July 3, 1979
IPN-79-44

Subject: Indian Point 3 Nuclear Power Plant
Docket No. 50-286
Information Requested on PWR
Feedwater Lines

INFORMATION REQUESTED ON PWR FEEDWATER LINES IN NRC REQUEST OF MAY 25, 1979

INDIAN POINT 3 NUCLEAR POWER PLANT

TITLE			PAGE
FEEDWATER - STRESSES + FREQ			3 OF
PROJECT: INT	AUTHOR: R.C. LEWIS 6/20/79	CHK'D. BY: Pierce-Nash 6/20/79	CHK'D. BY: RB-N
S.O.	CALC. NO.	FILE NO.	GROUP

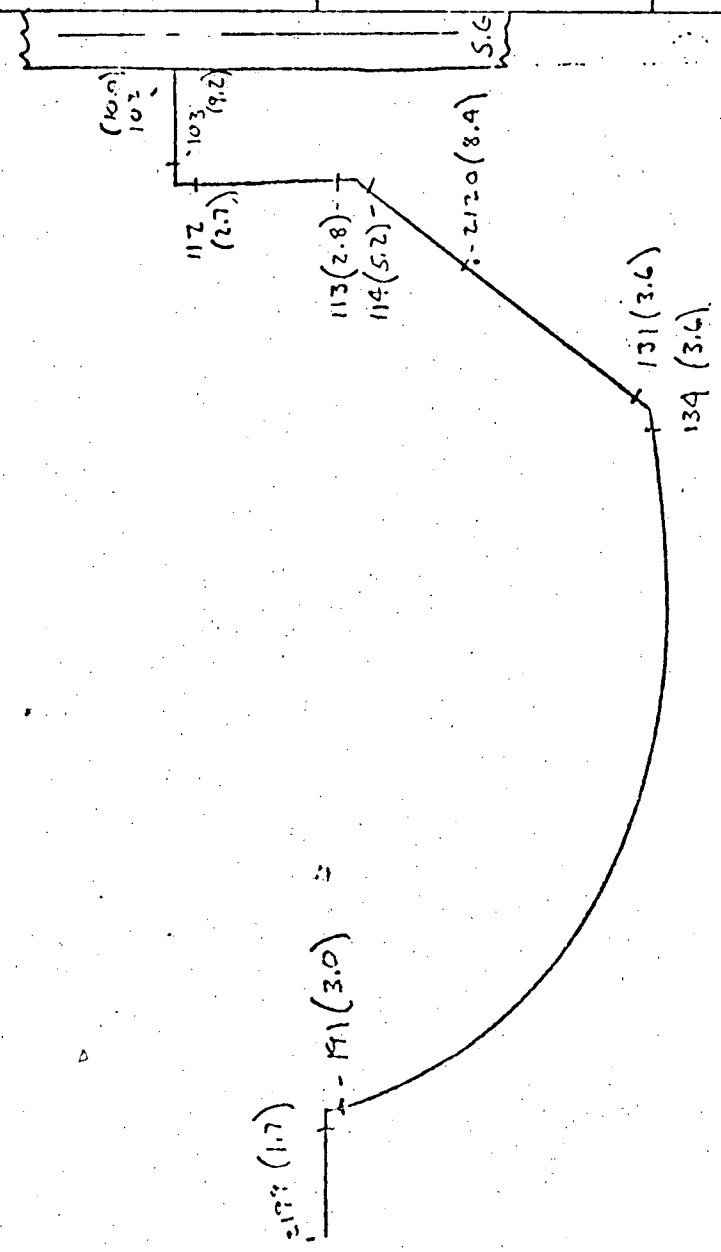
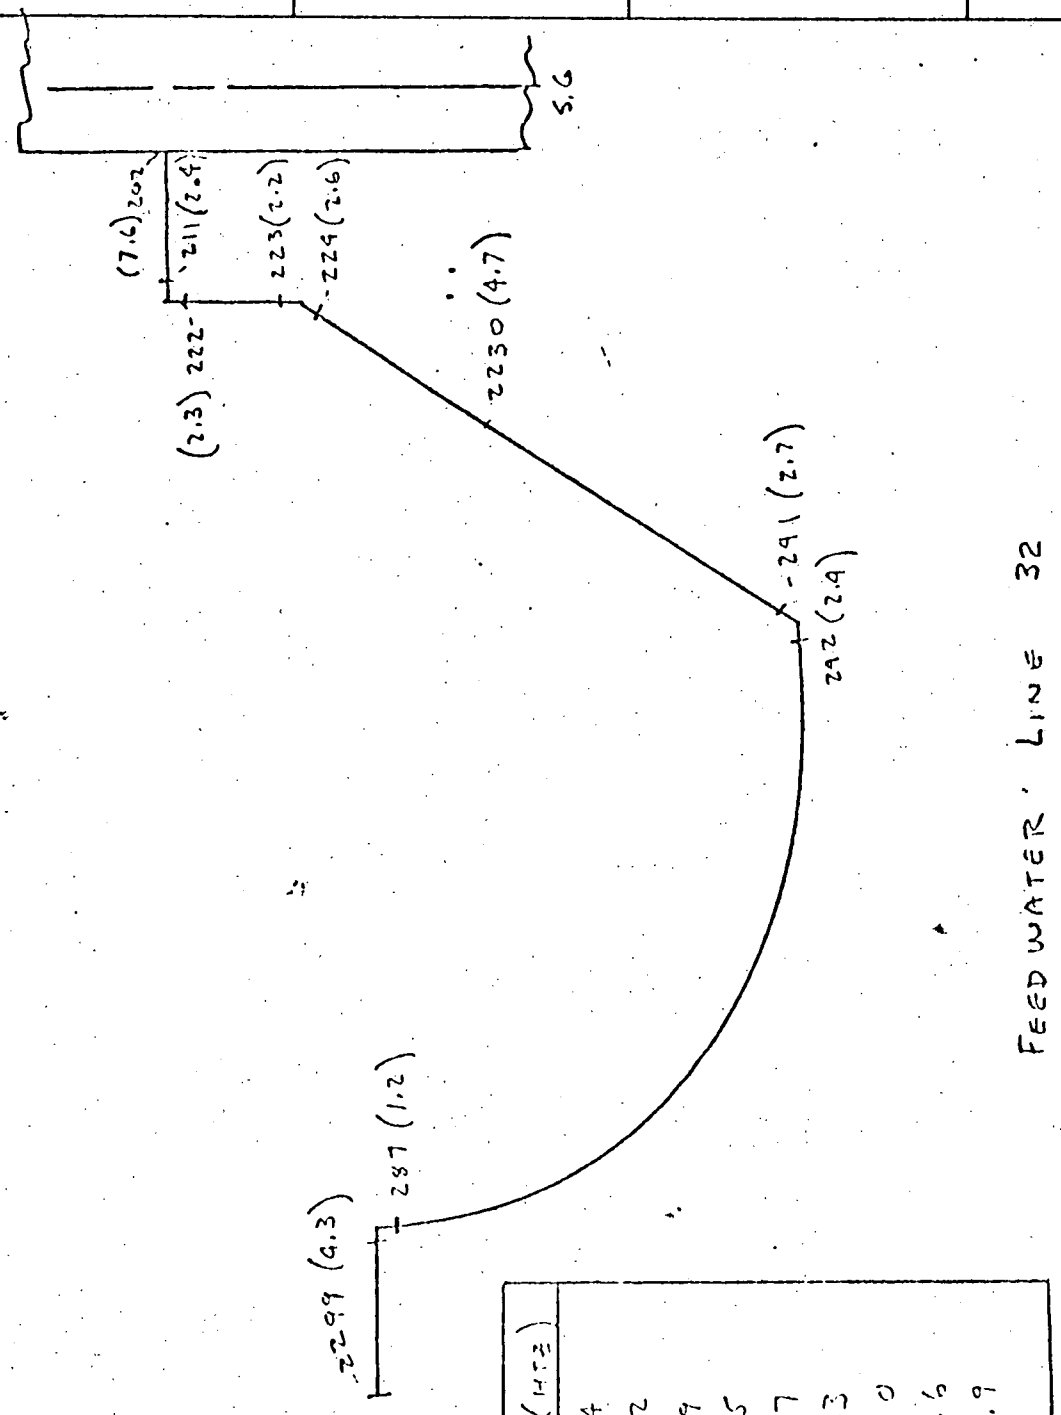
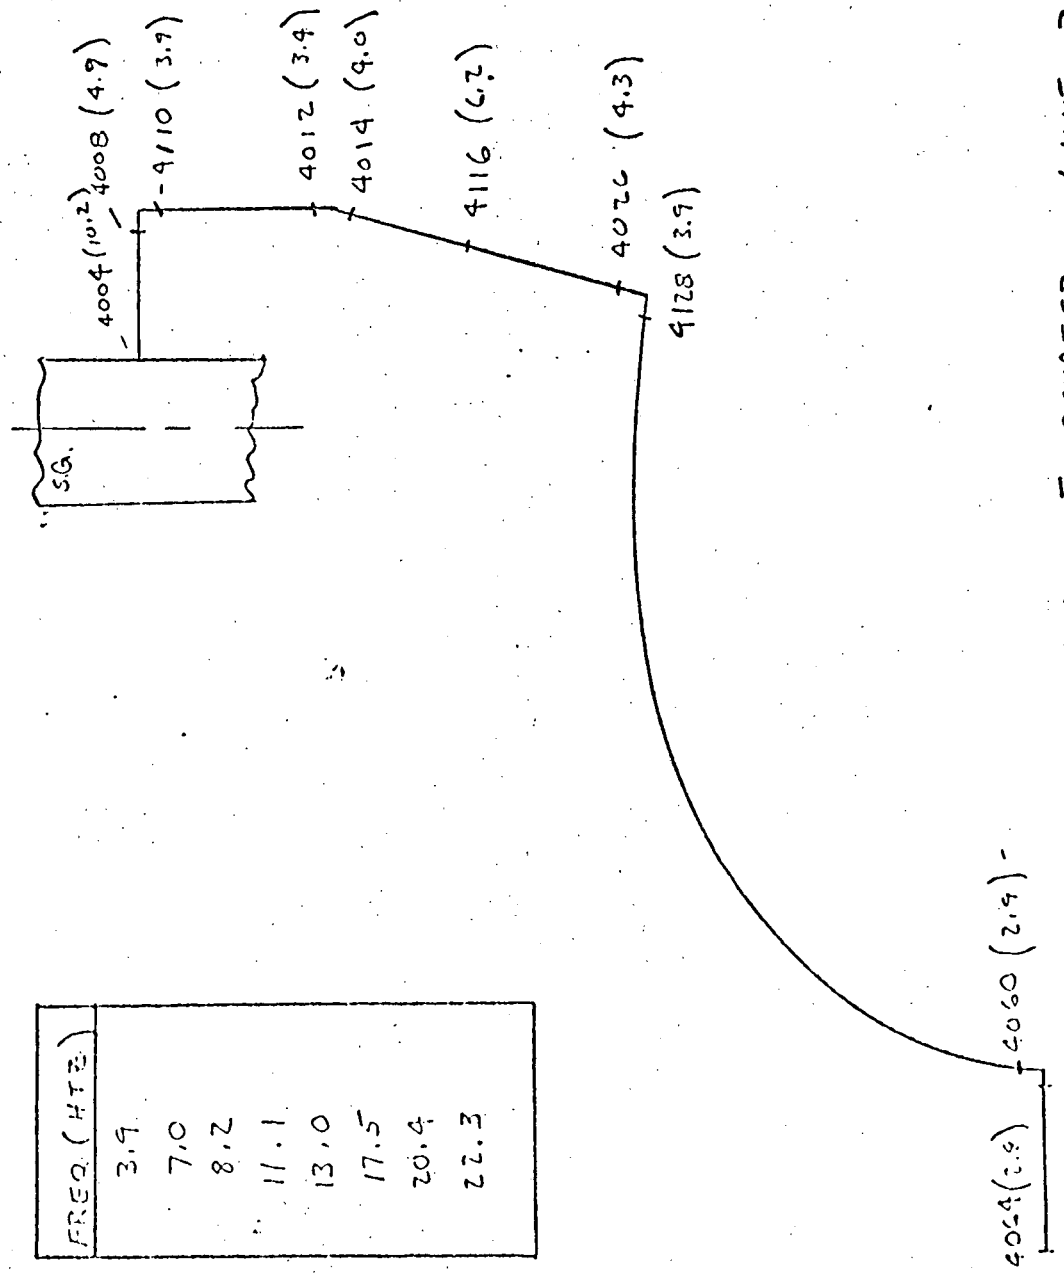
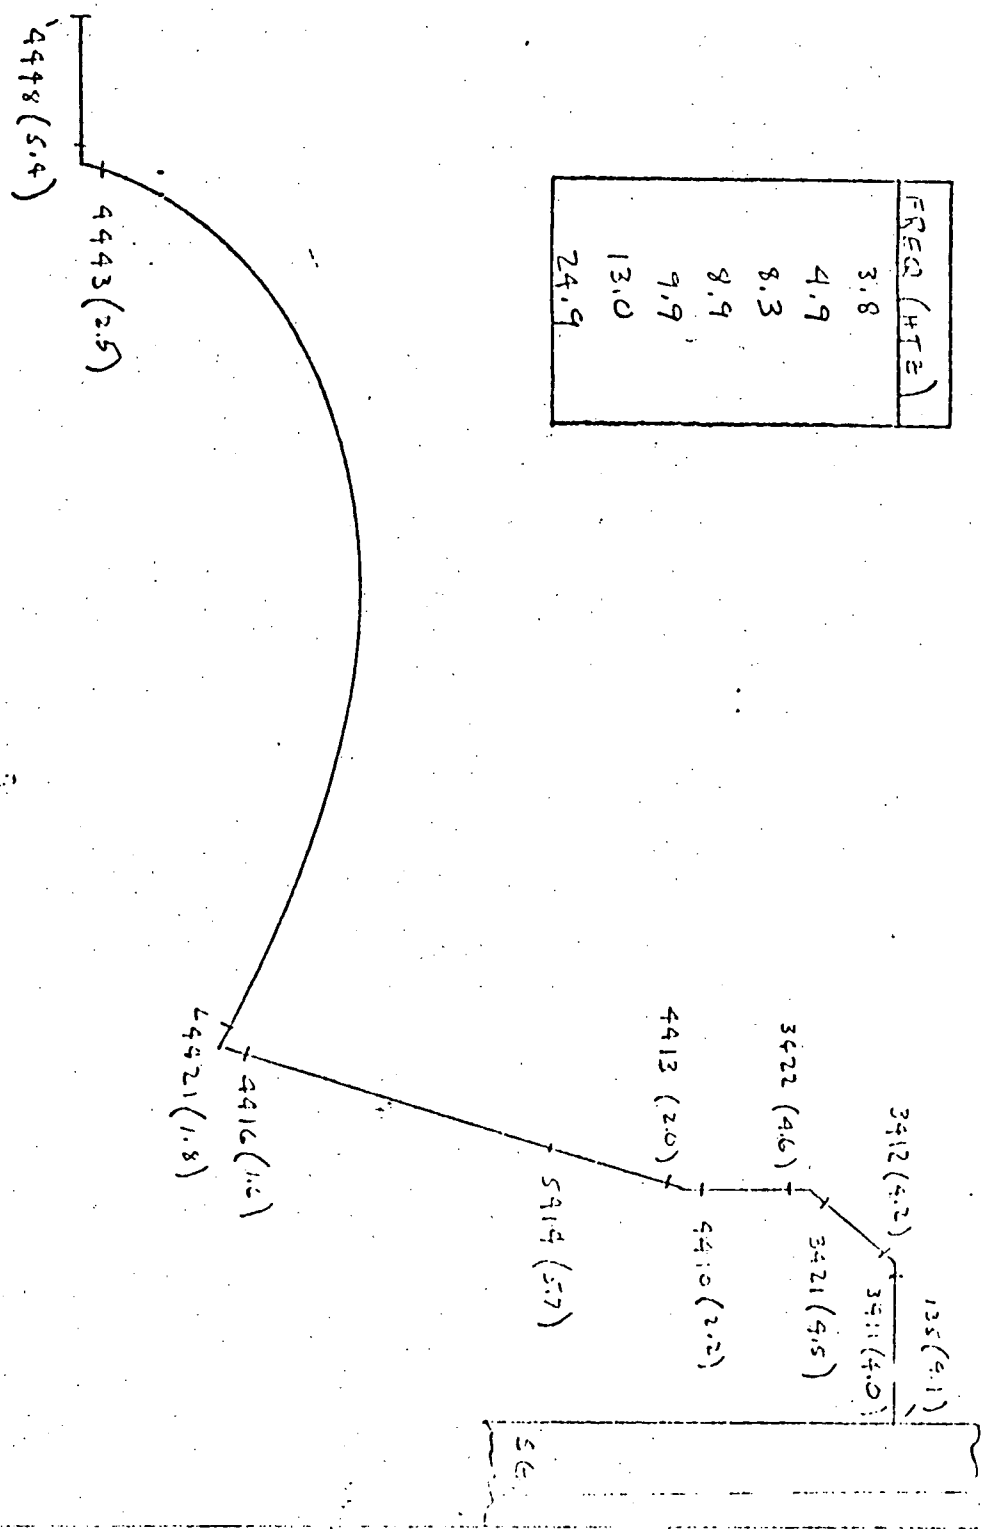
2. Provide the results of any stress or fatigue analyses which was performed for this system.

The seismic analysis results of the feedwater lines are presented on the attached Westinghouse sketches. These sketches show stresses at various points in the lines and all frequencies less than 25 HZ associated with the line are tabulated on the sketch. The United Engineers & Constructors stress report for the feedwater lines is also attached.

MODEL 44 FEEDWATER NOZZLE WELD PREP DETAILS

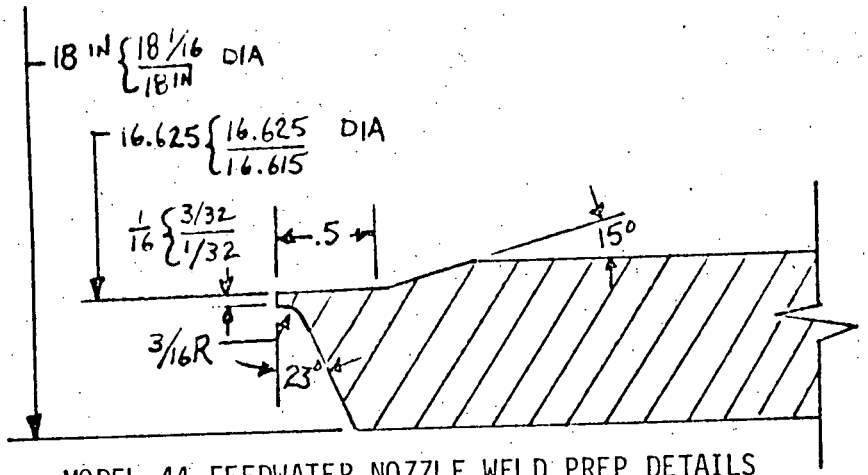
2. Provide the details of the welding process(es) used to make the nozzle-to-pipe, pipe to sparger and piping welds. Include details of welding such as preheat, joint configuration (include with or without backing ring), and post weld treatment, if any.

The configuration of the steam generator feedwater nozzle-to-pipe weld prep details is presented in the attached sketch. The details of the welding process used to make the feedwater piping system welds is contained in the attached weld procedure number 1 and 20. Backing rings were used in lieu of consumable inserts. Post weld treatment was performed as per the procedure on the nozzle-to-pipe.
